Visual Resources Review Board Meeting
Tuesday, April 28, 2026 at **6:00 PM**

AGENDA

REPORT TO THE VISUAL RESOURCES REVIEW BOARD

Subject: Review of subdivision entrance signs for Stonemeade Subdivision, north entrance, located at 341 Boring Road.

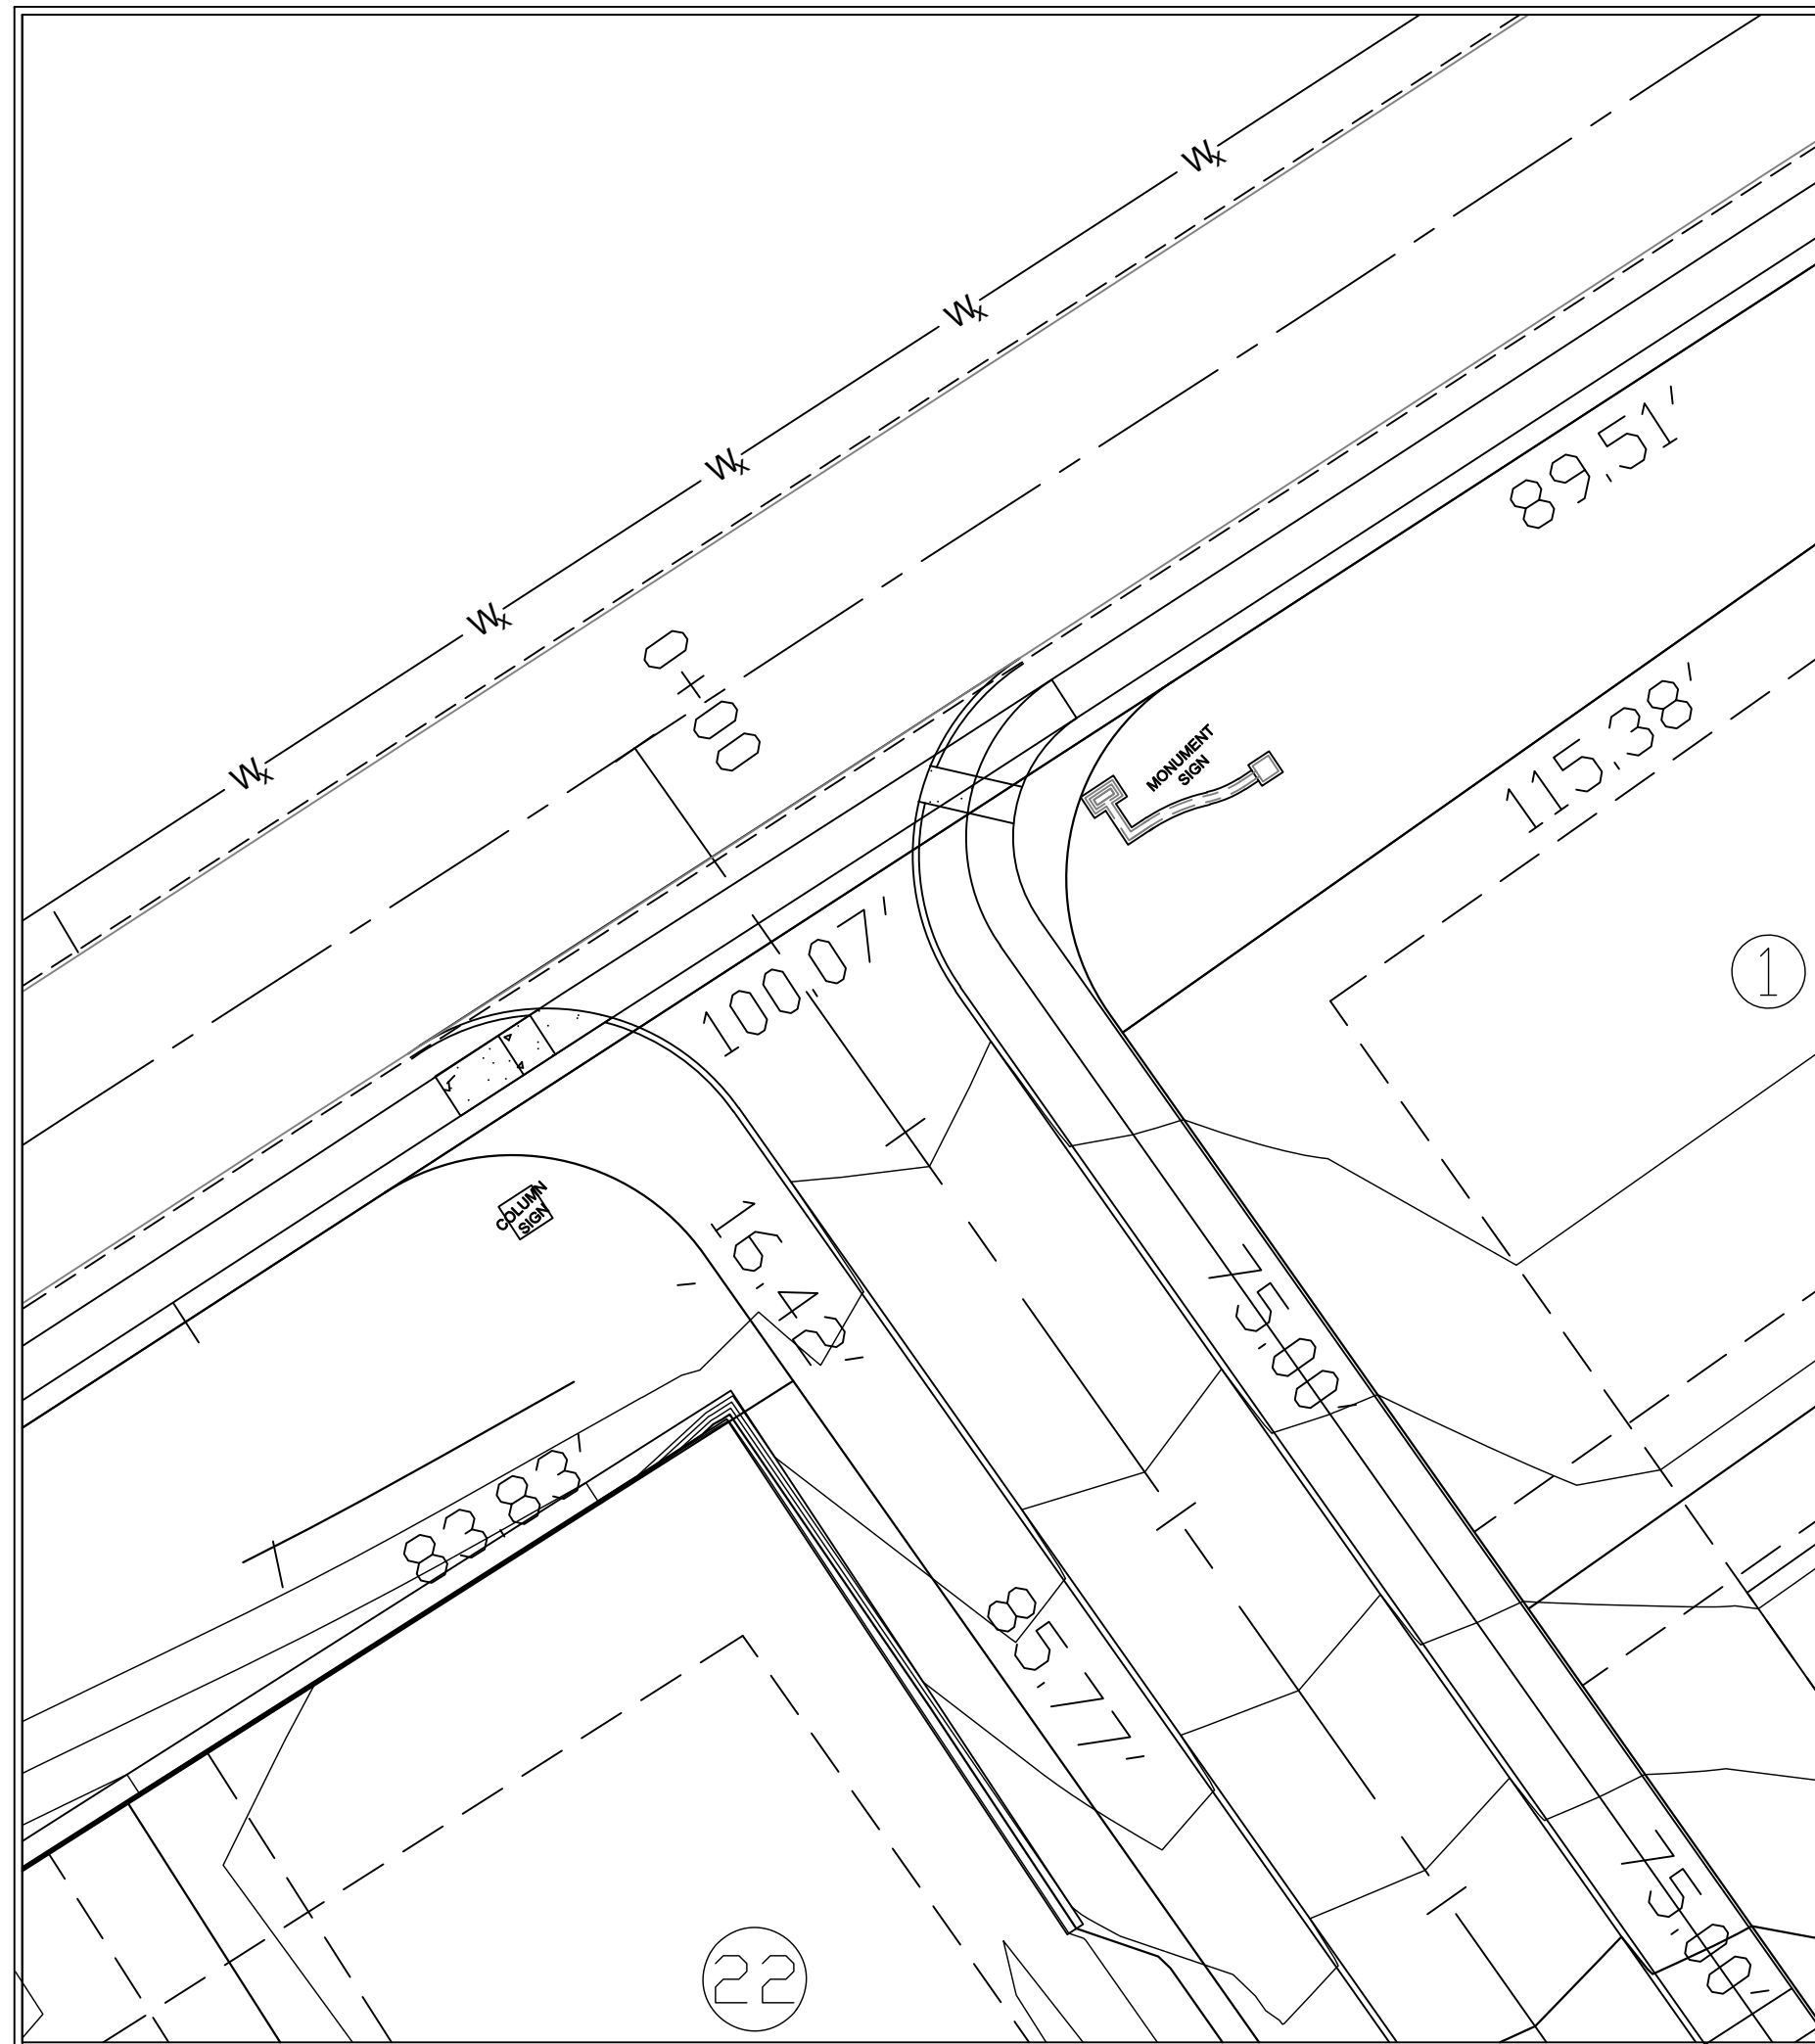
Discussion & Recommendations: Stonemeade Subdivision is requesting approval for entrance signs and related features at the north entrance to the subdivision located off Boring Road. The two signs would be located on stone wall and column features on both sides of the entrance street. The plan also includes landscaping around each entrance way feature. The material being used for the signs needs to be added to the plan, the signs lowered to six feet on the features, and the proposed lighting will need to be adequately frosted and meet the Town's outdoor lighting standards. Setbacks also need to be added to the plan and the actual location of the stone features may need to be adjusted in the field. The landscape plan will also need to be updated to include both common and botanical names of the plants being used. The species of Liriope needs to be verified as the non-invasive Muscaria, and staff has asked that Spirea not be used due to future invasive concerns. The staff can recommend approval subject to the noted plan additions and/or changes.

- To approve the signs subject to the plan additions and changes noted by staff.

Subject: Review of subdivision entrance signs for Stonemeade Subdivision, south entrance, located at 341 Boring Road.

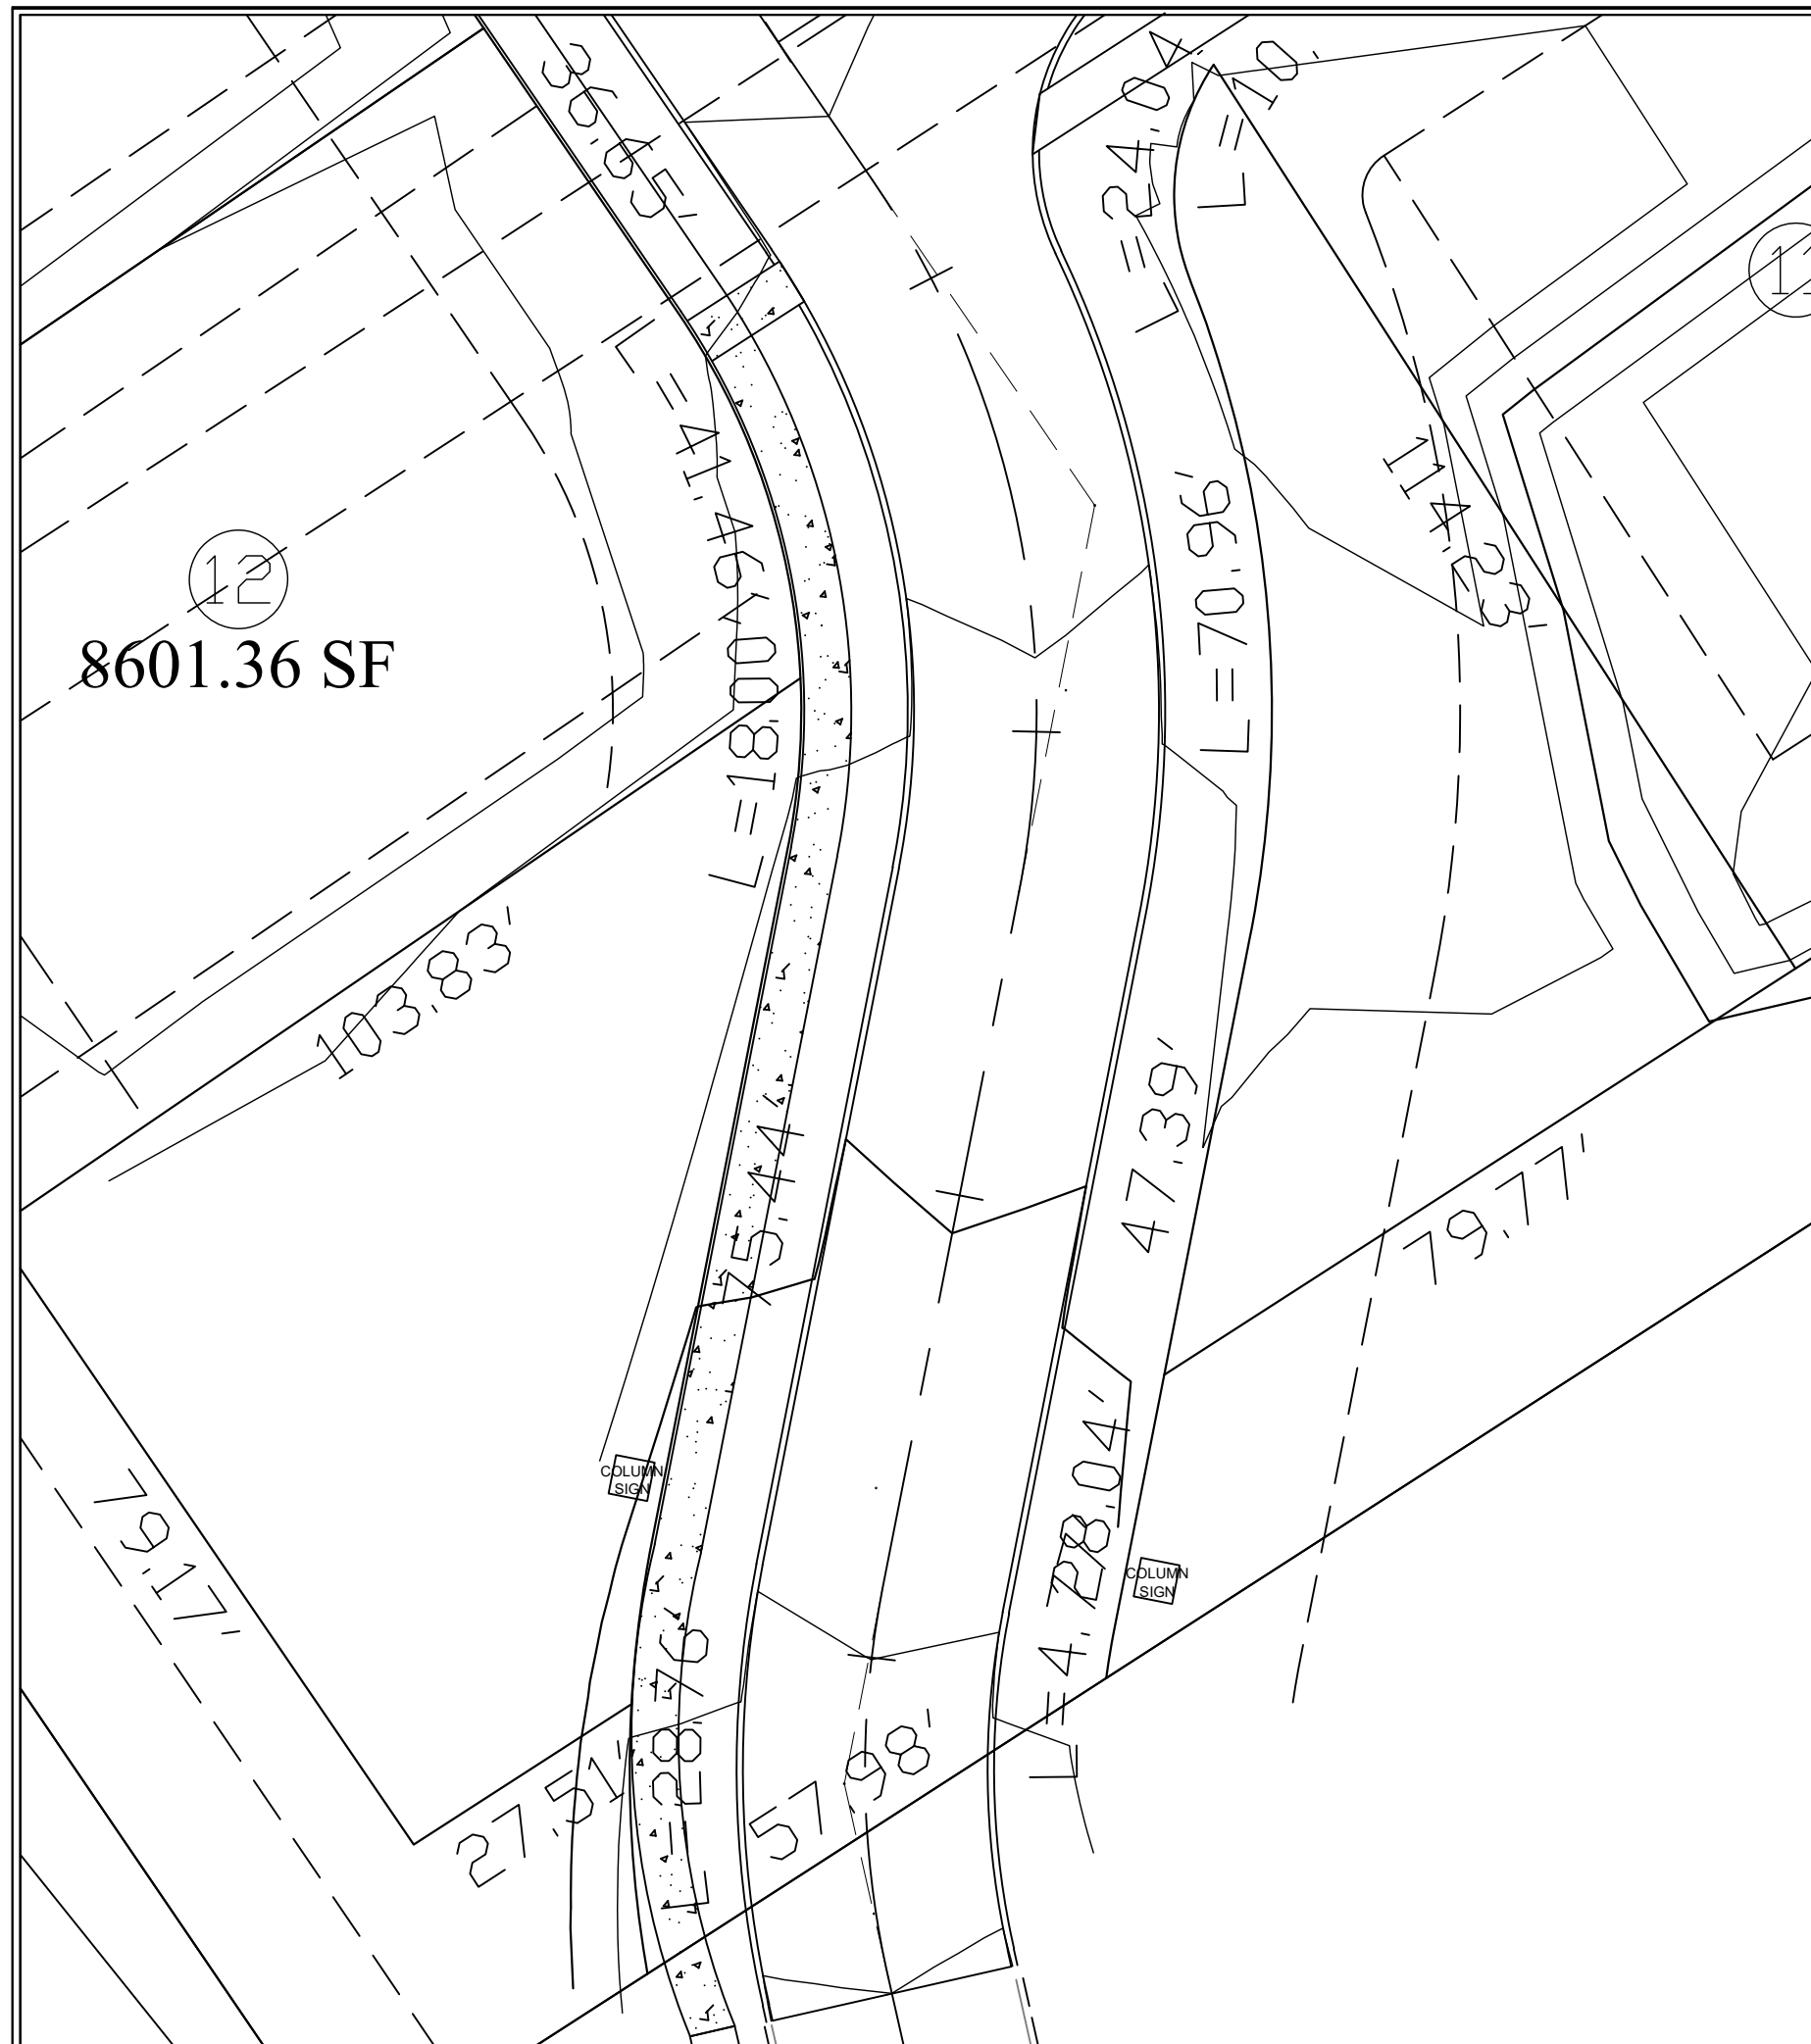
Discussion & Recommendations: Stonemeade Subdivision is requesting approval for entrance signs and related features at the south entrance to the subdivision. The two signs would be located on stone column features on both sides of the entrance street. The plan also includes landscaping around each entrance way feature. The material being used for the signs needs to be added to the plan, the signs lowered to six feet on the features, and the proposed lighting will need to be adequately frosted and meet the Town's outdoor lighting standards. The setbacks also need to be added to the plan and the actual location of the columns may need to be adjusted in the field. The landscape plan will also need to be updated to include both common and botanical names of the plants being used, and staff has asked that Spirea not be used due to future invasive concerns. The staff can recommend approval subject to the noted plan additions and/or changes.

- To approve the signs subject to the plan additions and changes noted by staff.

Sheet No.
 L700

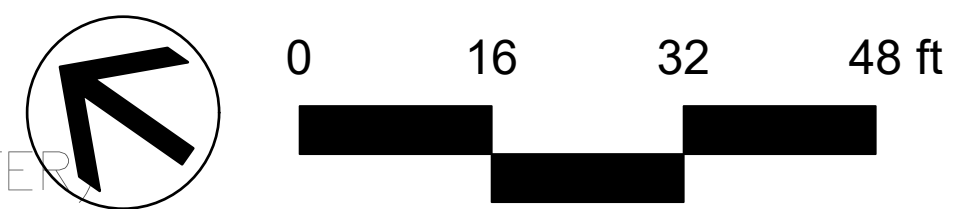
Discussion & Recommendations: The West End development is requesting approval for a landscape plan for the newest phase, Phase 3 of their larger development. The plan includes required shade trees, replacement trees, and landscaping around the building and between the building and parking spaces. The applicants are proposing to substitute/add shade trees elsewhere on the site for the trees that would normally be required in the front yard, between the building and the street. The Mixed-Use Town Center planning area allows buildings to be setback within 10 feet of the front property line. It is not practical to locate shade trees in the front yard given the proposed building location on this site. The applicants will also need to make a minor editorial correction to the Plant-List-Types table, but the proposed landscaping shown on the plan meets the towns' requirements. The staff can recommend approval subject to the table correction.

Proposed Motion: To approve the landscape plan subject to correcting the Plant List-Types table.
